MISSION PARK STONE OAK
POADP

Re: Mission Park Stone Oak

POADP # 676

P.O.A.D.P. REVIEW

PLAT # 200088

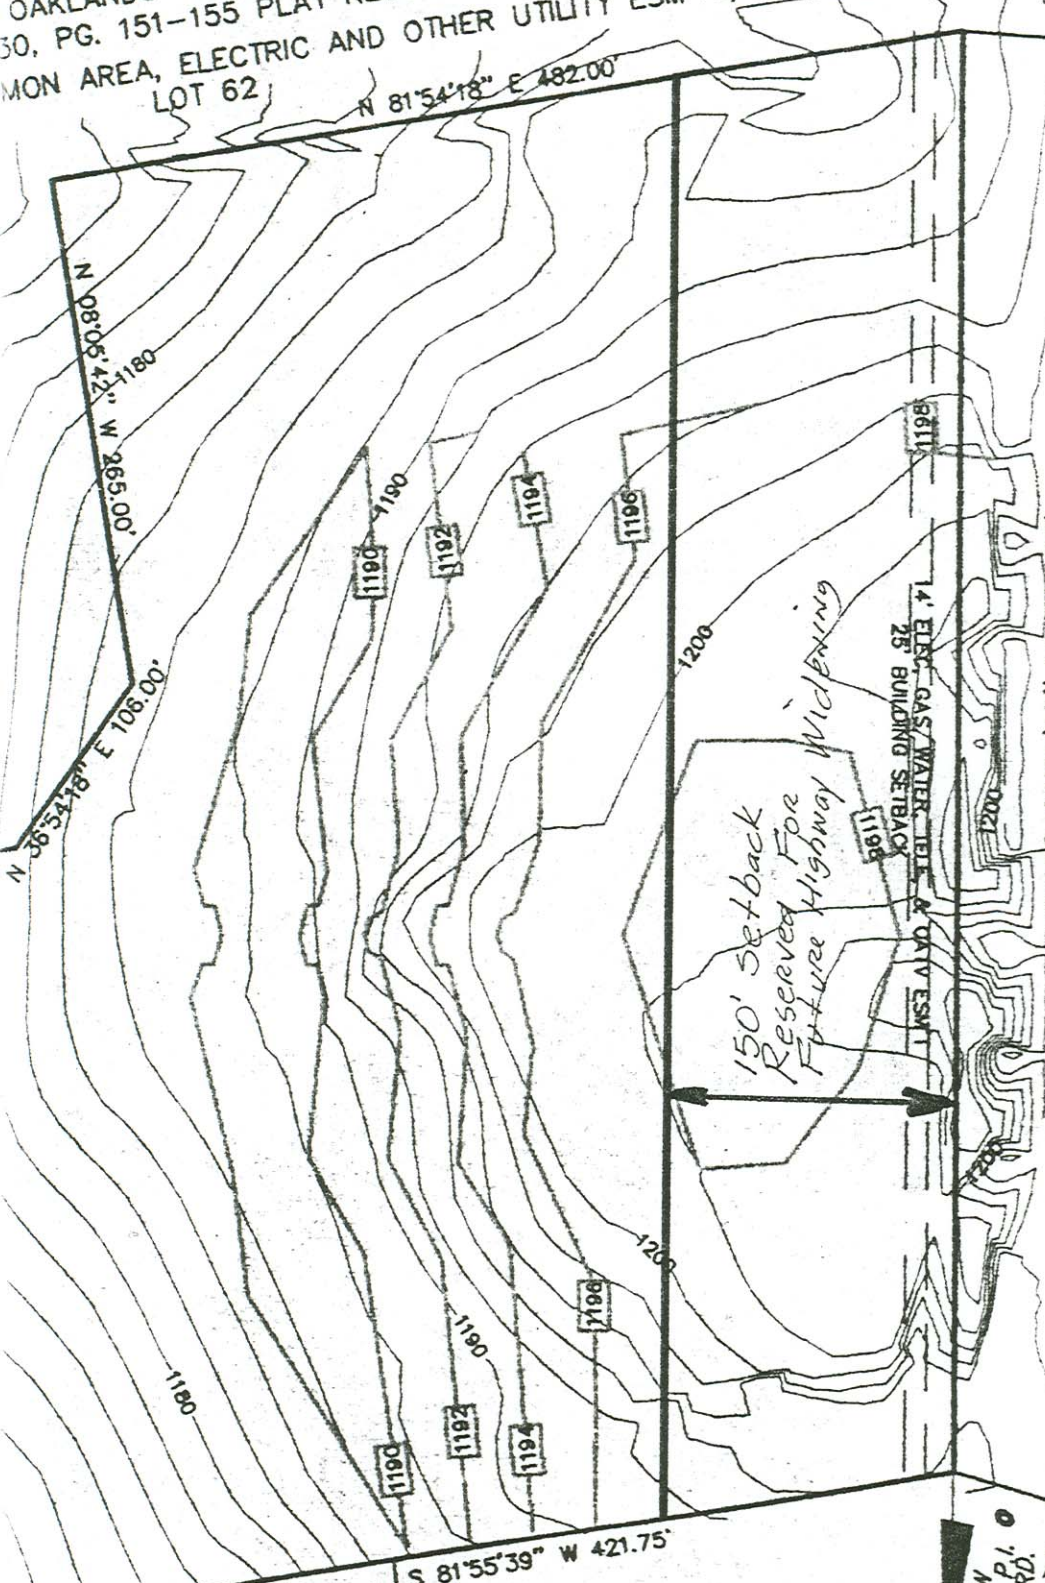
OTHER COMMENTS: *RECOMMEND 150' RESERVATION OF RIGHT OF WAY FOR FUTURE HIGHWAY WIDENING (SEE ATTACHED LAYOUT). ALL APPLICABLE BUILDING SETBACK DISTANCES WOULD BE MEASURED FROM THE 150' RESERVATION.

150' Setback
Reserved For
Future Highway Widening
